**WOKINGHAM
BOROUGH COUNCIL**

Outline Planning Approval Consultation

Application Number: 243099

Proposal: Outline application for the proposed erection of up to 111 no. dwellings with associated works, parking, landscaping, publicly accessible open space and access from Reading Road. (All matters reserved except for means of access.)

Visibility Splays

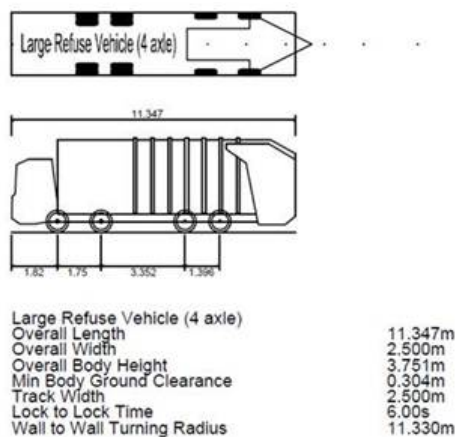
60. Visibility splays for the proposed new access have been submitted with reference to the 85th percentile speed of Reading Road. The calculations of the visibility splays would need to be submitted. **These calculations are still required to be submitted. These have been submitted and are acceptable.**
61. The visibility splay to the west appears that it maybe obstructed by the tree as shown below.

62. Evidence would need to be submitted that this is not the case. **A statement has been made that the visibility splay is not impacted by the tree, though no evidence has been provided. The size of the tree trunk shown on the plan does not represent what is on the ground. This tree is proposed to be removed and therefore no further comments..**
63. Any landscaping within the splays would need to be maintained so that it is less than 0.6m high. **This has been agreed which is welcome.**
64. Pedestrian and cycling visibility splays need to be provided for the proposed access onto Reading Road. **These are still required. These have been provided which is welcome. No further comments.**

Swept Paths

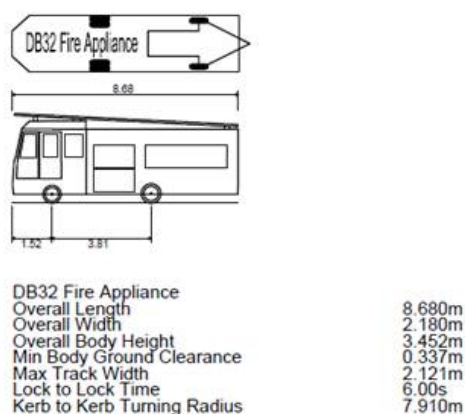
65. All movement swept paths of a refuse vehicle have been provided which is welcome. However, the dimensions are not acceptable. The dimensions that would need to be used are as follows: -

These have been provided. However, there are no swept paths for the refuse vehicle turning out. These need to be submitted. The swept paths of the refuse vehicle entering the site clearly shows that when the vehicle enters the access no vehicle can be waiting to exit. In addition, from both directions, the overhang of the vehicle is at the end of the pavement. The width of the access has been widened and the radii increased which has improved the swept paths and these are therefore acceptable.

Highways would need to see swept paths of the refuse lorry entering the site from both directions whilst a car is waiting to exit. These have not been submitted and are required. However, based on the comments above I doubt they would work. The width of the access has been widened and the radii increased which has improved the swept paths and these are therefore acceptable.
